Access Compliance Report

Public Rights-of-Way

Intersection ID: 10025412	Main Street: E_CARSON_BV	Cross Street: N/A	Location: E
ADA ID: DA2261380488	Ramp Type: Perp	Initial Pass/Fail: Fail	Overall Compliance: No
Severity Score: 12.5			
Codes/Mitigation Info/Possible Solution		Field Measurements/Component Compliance

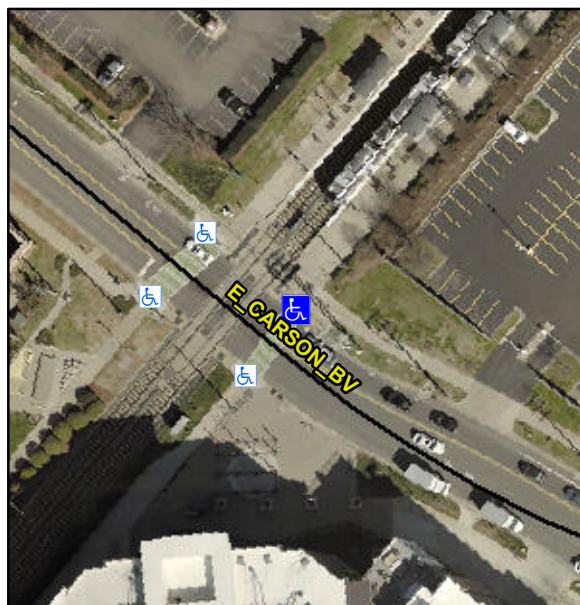
Not Found, R304.2.2

Compliance	Description	Data	Compliance	Description	Data
N/A	Ramp Length (in)	72.0	No	Ramp Slope (%)	11.4
Yes	Ramp Width (in)	96.0	Yes	Ramp XSlope (%)	0.6
N/A	Flare Type LT	N/A	N/A	Flare Type RT	N/A
N/A	Flare Slope LT (%)	N/A	N/A	Flare Slope RT (%)	N/A
N/A	Flare Traversable LT?	N/A	N/A	Flare Traversable RT?	N/A
N/A	Landing Length (in)	N/A	N/A	DWS Provided?	N/A
N/A	Landing Width (in)	N/A	N/A	DWS Contrast?	N/A
N/A	Landing Slope (%)	N/A	N/A	DWS Length (in)	N/A
N/A	Landing X Slope (%)	N/A	N/A	DWS Full Width?	N/A
N/A	Landing Curb? (Y/N)	N/A	N/A	DWS Offset (in)	N/A
N/A	Shared Landing?	N/A			
N/A	Gutter Ponding?	N/A	N/A	Gutter Slope (%)	N/A
N/A	Gutter Lip Ht (in)	N/A	N/A	Gutter X Slope (%)	N/A
N/A	Painted X Walk1?	Yes	N/A	Painted X Walk2?	N/A
	X Walk 1 Direction	To SW		X Walk 2 Direction	N/A
N/A	X Walk 1 Width (in)	113.0	N/A	X Walk 2 Width (in)	N/A
	X Walk 1 Slope (%)	3.9		X Walk 2 Slope (%)	N/A
	X Walk 1 X Slope (%)	2.3		X Walk 2 X Slope (%)	N/A

Remove & Replace Entire Ramp.
